CERTIFICATE OF REMEDIATION

Property: 501 Highland Street, Lot 16, Block 9, Woodland Heights Subdivision. The property includes a historic 1,654 square foot two story residence and two story garage-apartment situated on a 5,000 square foot (50' x 100') corner lot.

Proposal: Alteration – *Revision.* The applicant has removed all of the original historic windows on the house (14 total) without a COA and has installed new wood windows. This action was outside the scope of work approved in four earlier COAs for this remodel, and was done without staff knowledge or prior HAHC approval.

EAST SIDE ELEVATION FACING HELEN STREET

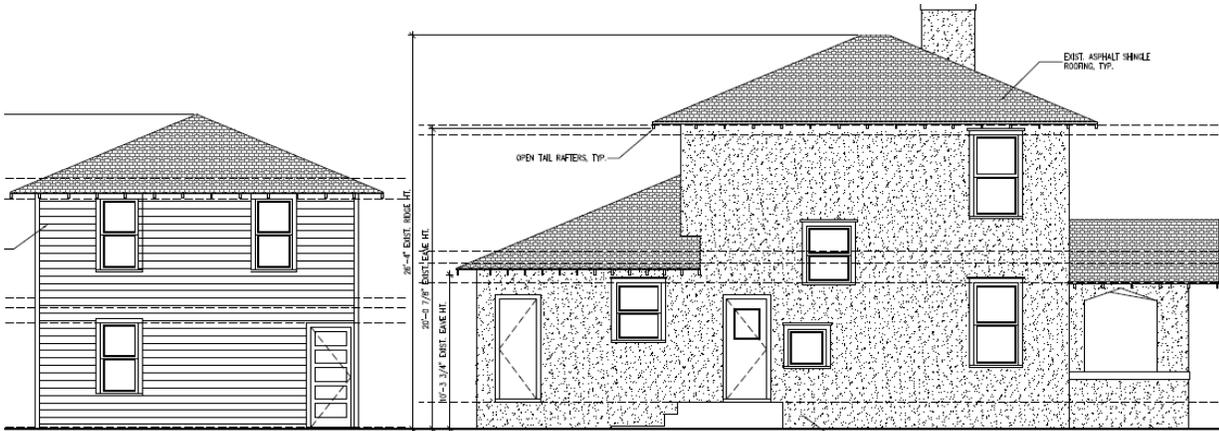
Replaced Window

WEST SIDE ELEVATION

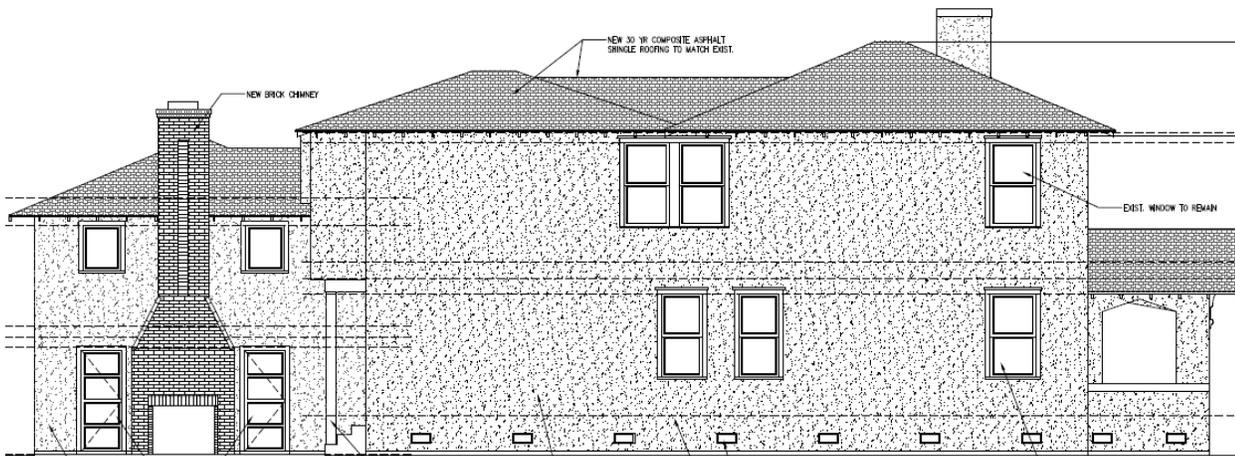
Replaced Window
